AMENDMENT OF SOLICITATION/MODIFICATION OF CONTRACT

1. AMENDMENT/MODIFICATION NO. Eight (8)	2. EFFECTIVE DATE 6/20/83	3. REQUISITION/PURCHASE REQUEST NO. RFP-ADM-82-399	4. PROJECT NO. (If applicable)
5. ISSUED BY U.S. Nuclear Regulatory Commission Division of Contracts Washington, DC 20555	6. ADMINISTERED BY (If other than block 5)

STATEMENT OF WORK

"5h. System Augmentation Requirements

MARYLAND NATIONAL BANK BUILDING

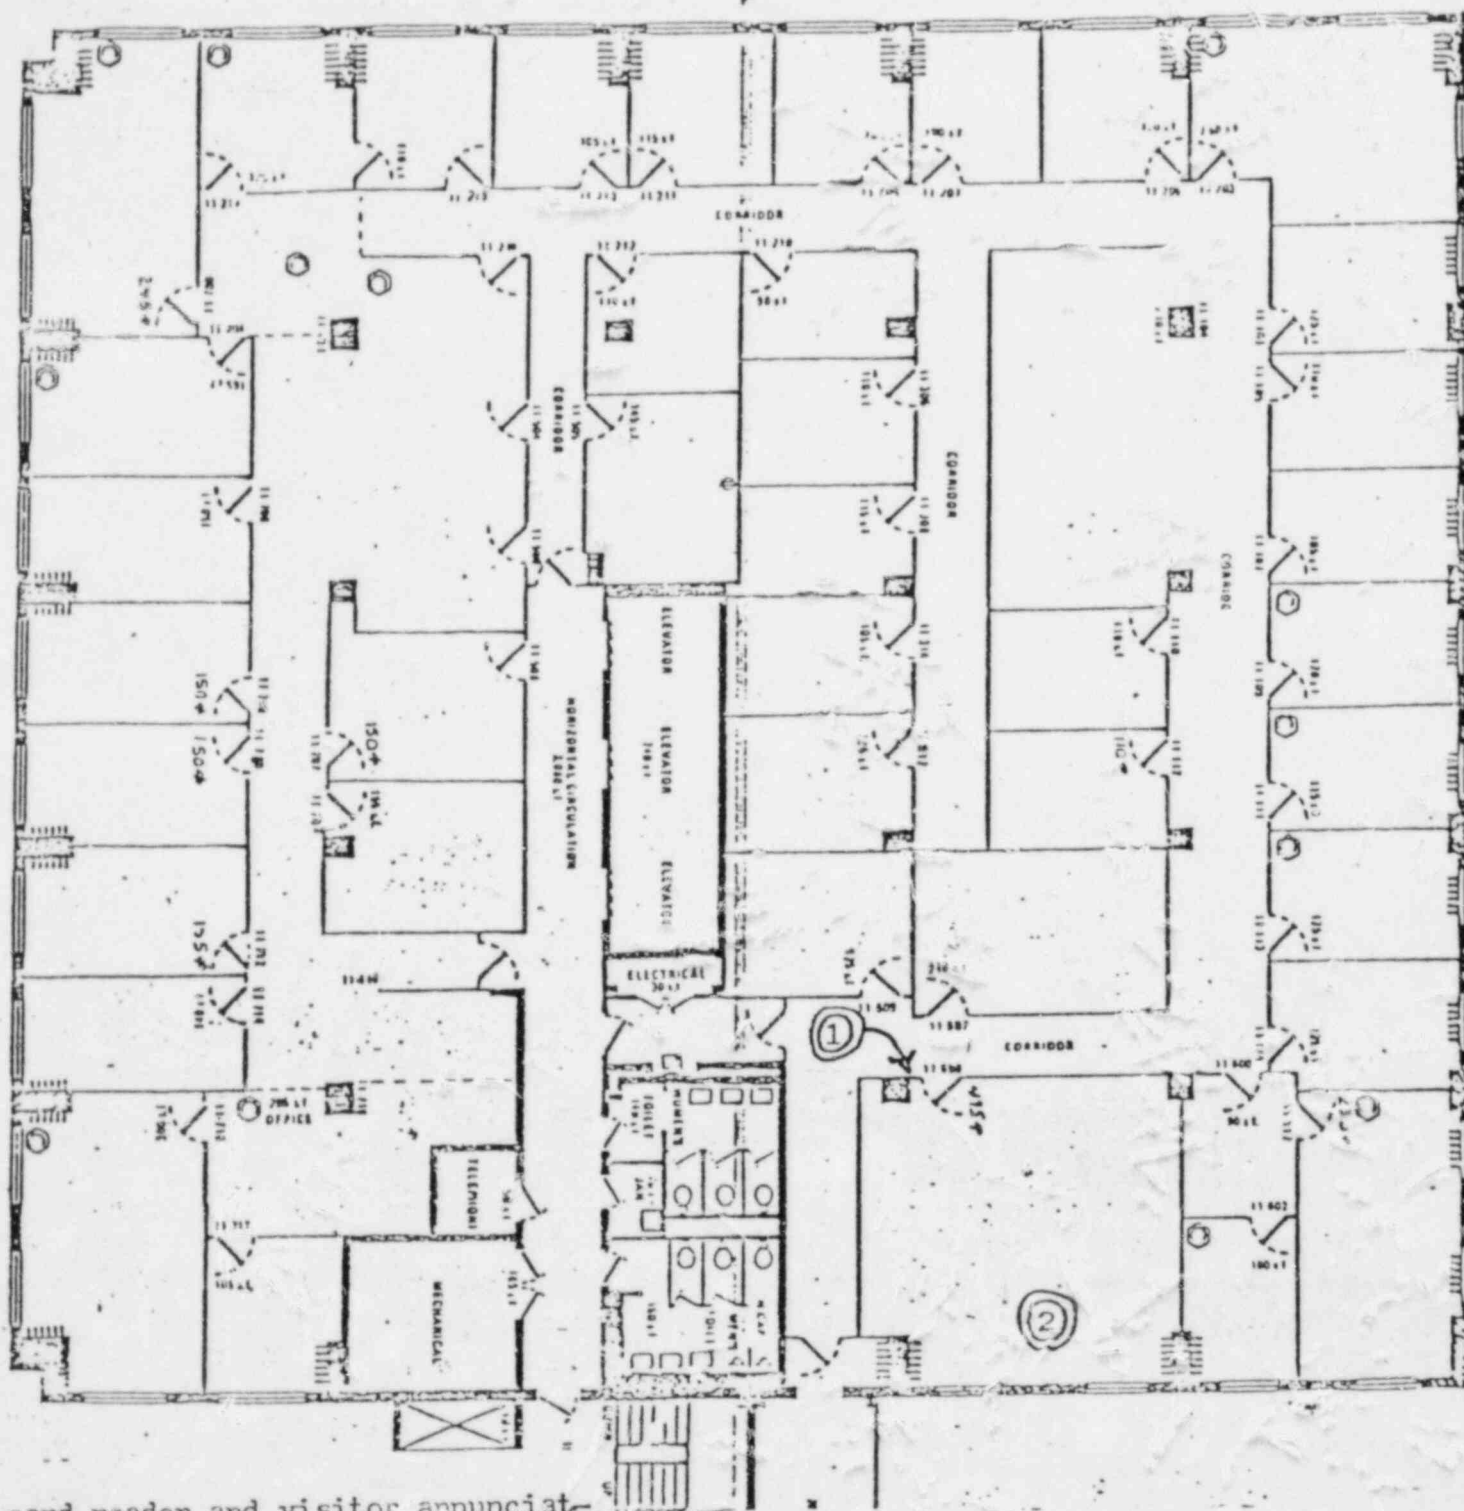
• Install card reader and visitor annunciator or pushbutton switch at location (1) •

• Install audible annunciator and egress pushbutton switch in general area (2) •

ii. Maryland National Bank Building, Room 11606 (Provide 1 New Card Reader, Item 19b):

Reference the partial floor plan, 11th floor, Maryland National Bank Building, attached hereto. One new card reader (Item 19b), including an electrical door strike, transformers and magnetic contacts, shall be provided and installed at the entrance door to room 11606. The contractor shall connect the reader to one of the three existing systems multiplexers in the Maryland National Bank Building to provide full on-line operation from the existing TAC-1000 central processor located in the Phillips Building.

An Egress Push Button switch shall be provided in room 11606 to provide the entry override function to permit remote unlocking of the entry door from within the room.

An audible annunciation (door bell) system with a push button switch shall be provided and installed, with the switch located near the card reader. The annunciation within the room shall be sufficiently loud to be heard anywhere within the computer room environment at maximum ambient noise levels.

11th floor plan

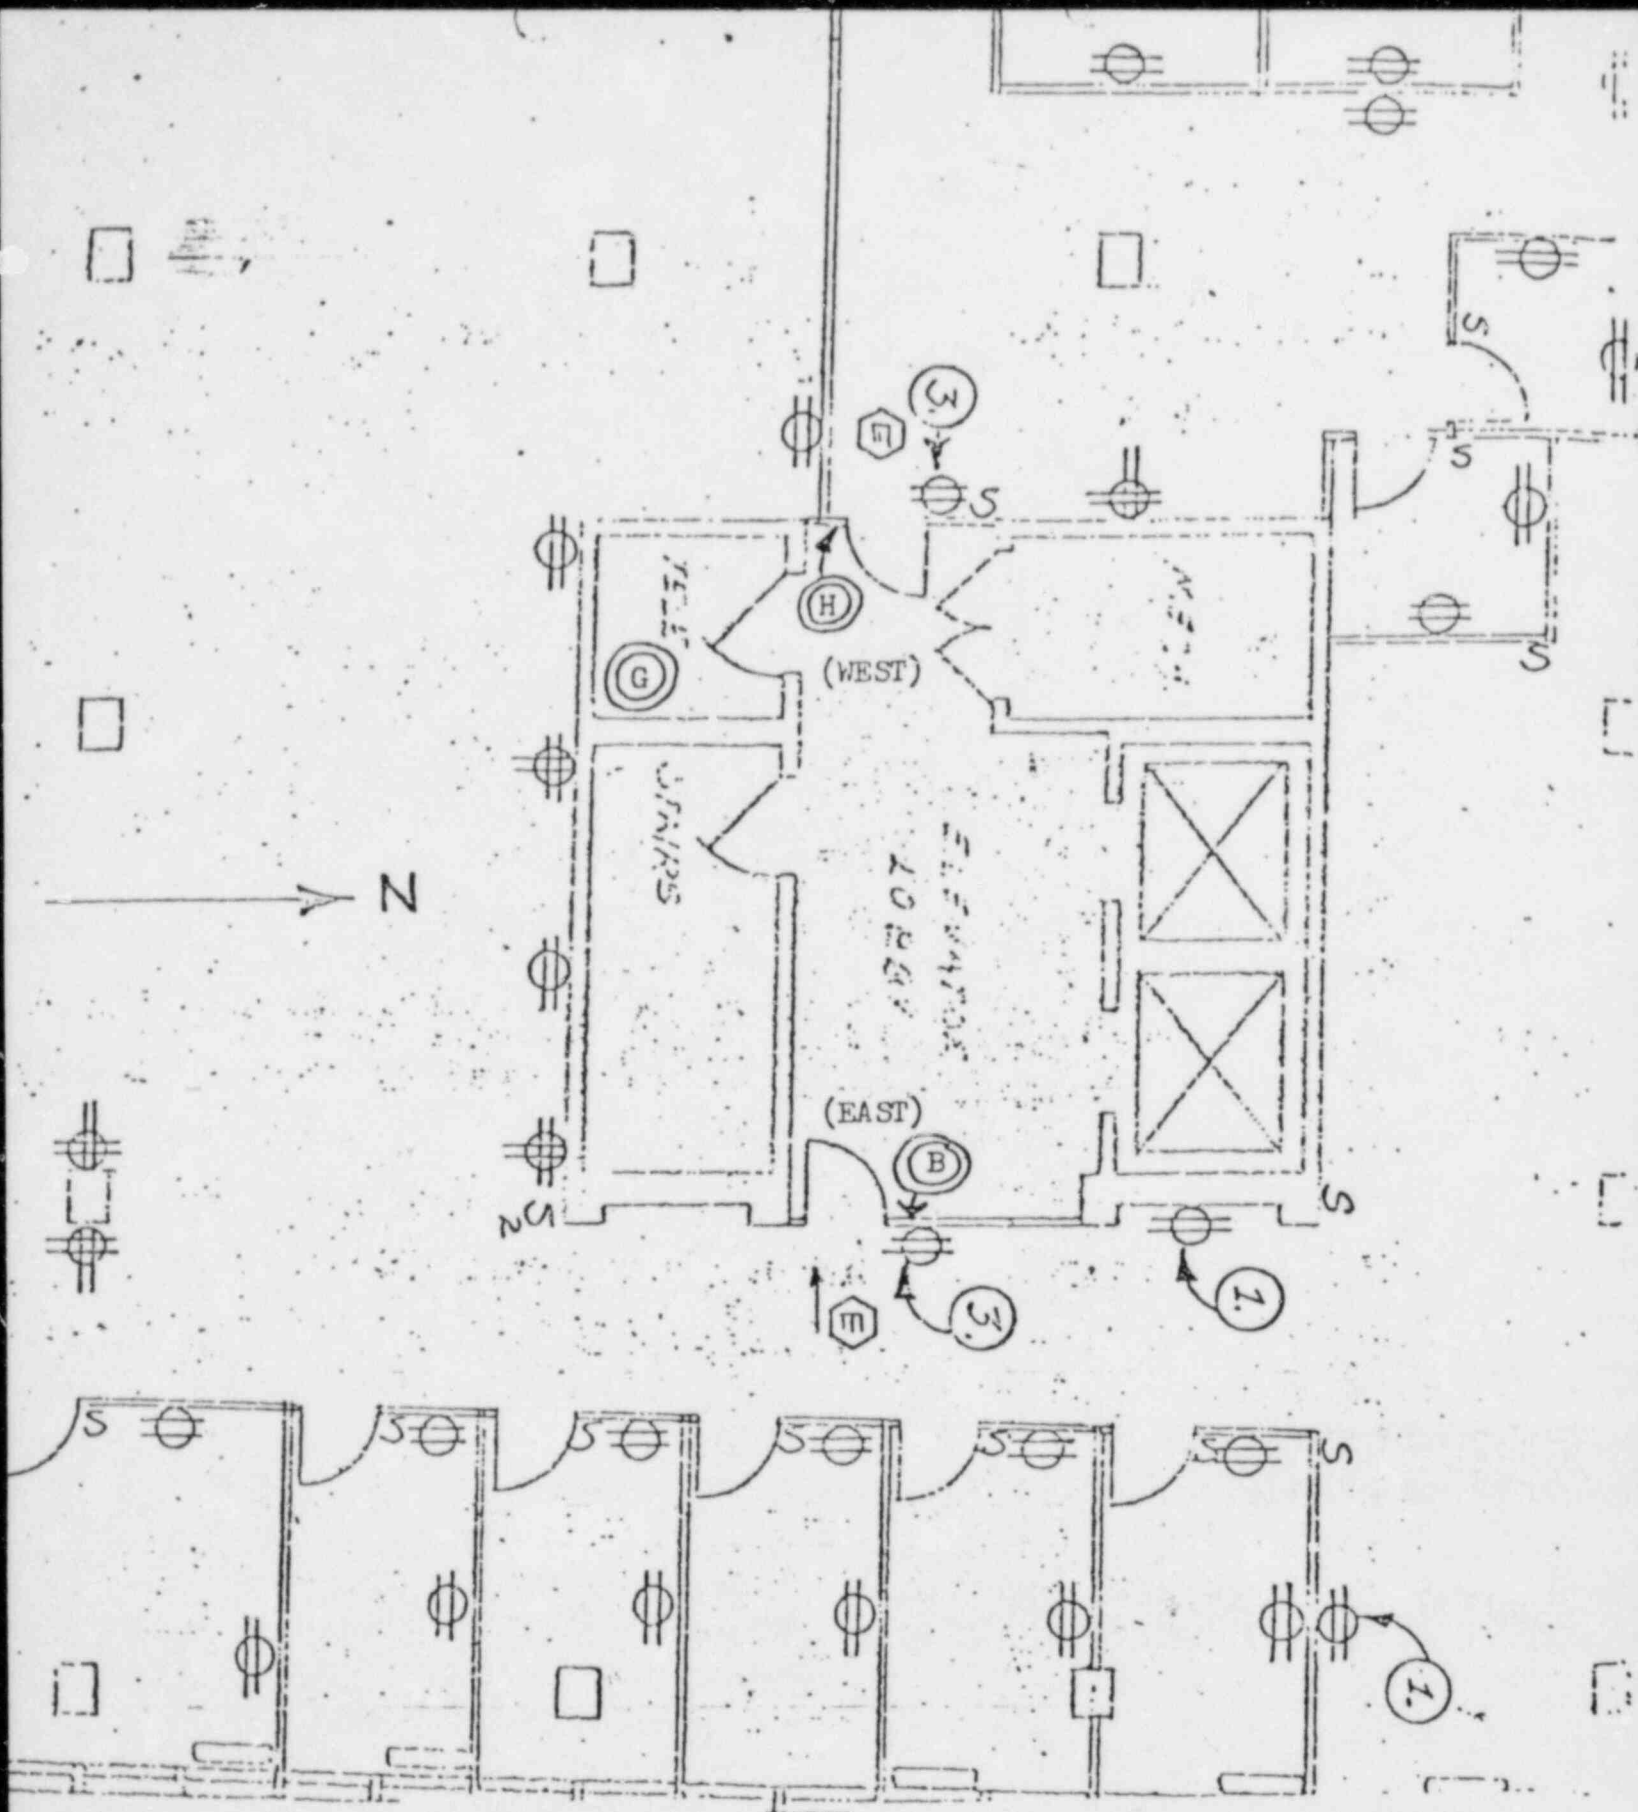
- 1. Install card readers at locations (H) and (B).
- 2. Install multiplexer and modem in telephone closet at location (G).

i. Woodmont Building, 4th and 5th floors (Provide 4 New Card Readers):

Reference the partial floor plans, 4th and 5th floors, Woodmont Building, attached hereto: One (1) new multiplexer, one (1) new modem and four (4) new card readers (one item 19a, one item 19b, two item 19c's), including electrical door strikes, transformers and magnetic contacts, shall be provided and installed at the Woodmont Building. One (1) new modem shall be installed at the Phillips Building. The Woodmont system shall be connected for full on-line operation from the existing TAC-1000 central processor located at the Phillips Building. The Government has provided 115 VAC, 60Hz electrical power and door knobsets at each of the four (4) door locations. In addition, a type 3002, C2 conditioned, 4-wire duplex telephone line has been provided in the 4th floor telephone closet to connect the new multiplexer to the existing TAC-1000 central processor located at the Phillips Building.

(partial) 4th floor plan

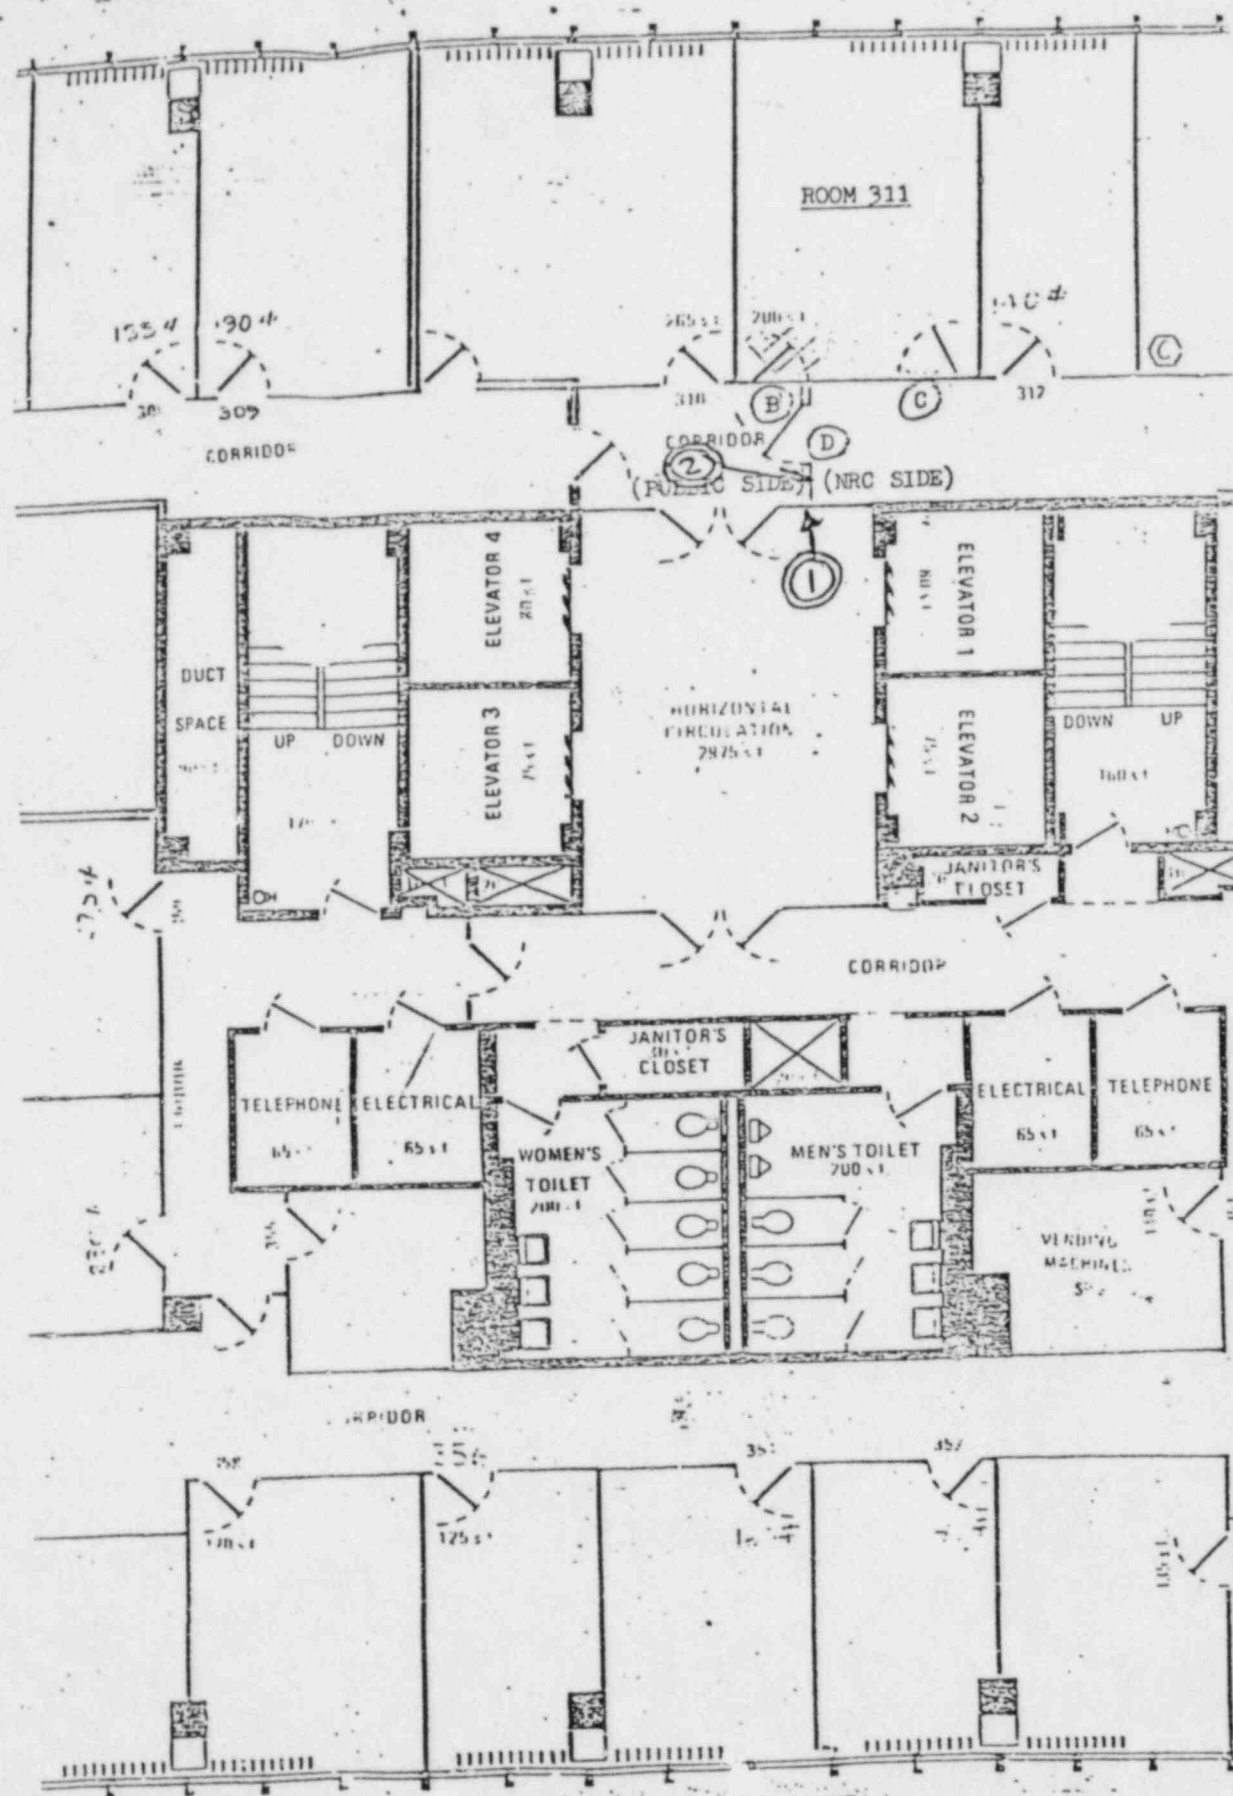
Relocate one (1) existing card reader from location (1) to location (2).

i. East-West (West) Towers (Relocate 1 Card Reader):

Reference the partial floor plan, 3rd floor, East-West (West) Towers, which is provided. The contractor shall relocate Terminal No. 65 from its present location on the 3rd floor, to a new door which will be constructed near the present location by the Government. The existing card reader shall be relocated, but the existing electric door strike and magnetic contacts shall remain in the present location. The contractor shall provide and install one new strike and one new set of magnetic contacts at the new reader location. Wiring for 115 VAC power and for signal lines shall be disconnected from the present location and reconnected at the new location.

After Terminal No. 65 is relocated, it shall be connected to provide full on-line operation from the existing TAC-1000 central processor located in the Phillips Building.

NRC will patch and paint any holes in walls or doors created by the removal and relocation of equipment and otherwise restore the previous site of terminal no. 65 only to its original condition and appearance."

(partial) 3rd floor plan

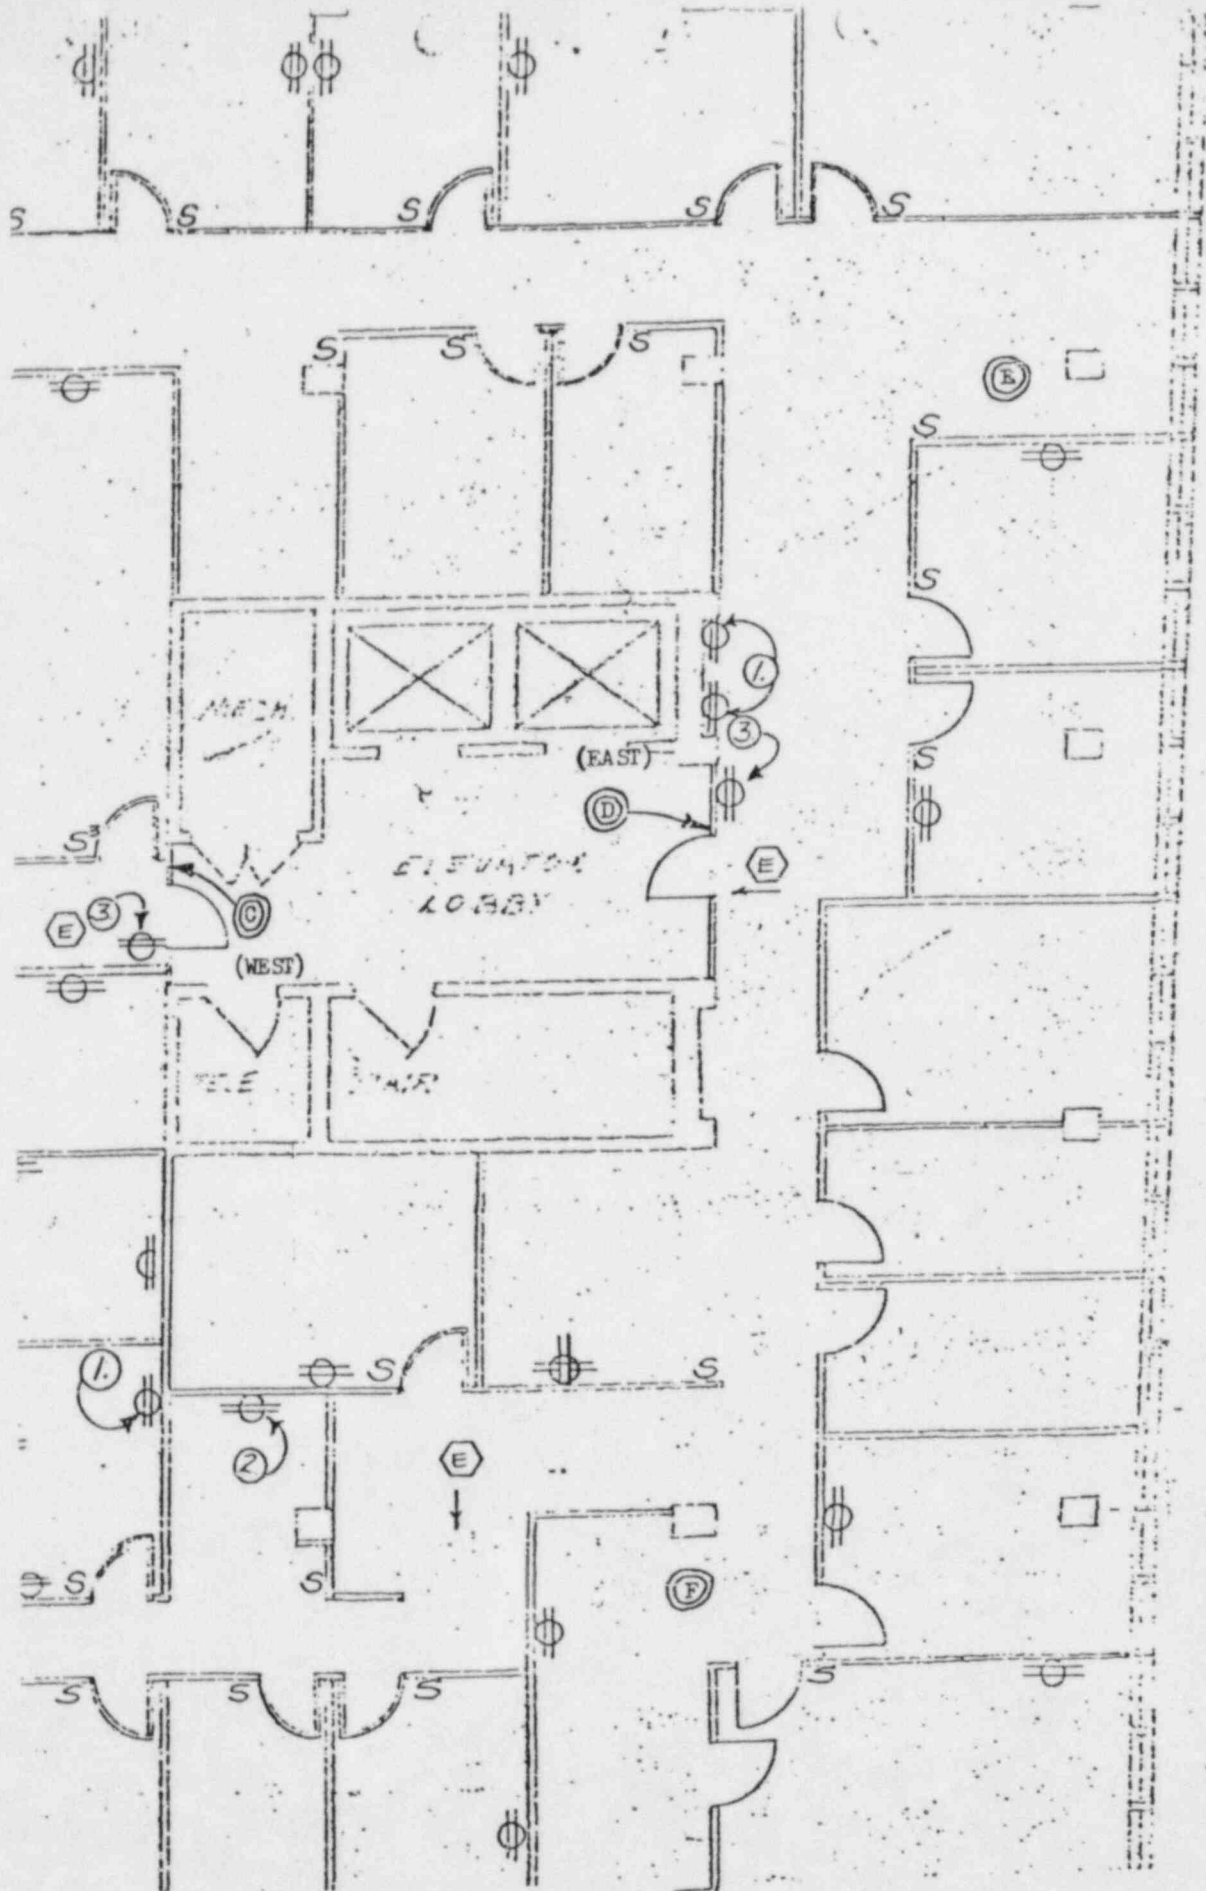
1. Install card readers at locations (C) and (D).
2. Install two (2) egress pushbutton switches for card reader (D) with one (1)

(i) For the 5th floor (east) elevator lobby card reader (item 19b), provide an Egress Push Button switch at each of the two (2) 5th floor locations as shown on the partial floor plan.

(ii) For the (west) elevator lobby card readers on both the 4th and 5th floors (Item 19c's), the card reader systems shall be interconnected with the building fire alarm system so that both doors are

electrically unlocked in the event of a building fire alarm. Also, the electric strikes for these two doors shall automatically unlock in the event of failure of the card reader or electrical strike primary 115 VAC power.

{iii} For the (east) elevator lobby card readers on both the 4th (Item 19a) and 5th (Item 19b) floors, both doors shall remain locked in the event of failure of the card reader or electrical strike primary 115 VAC power.
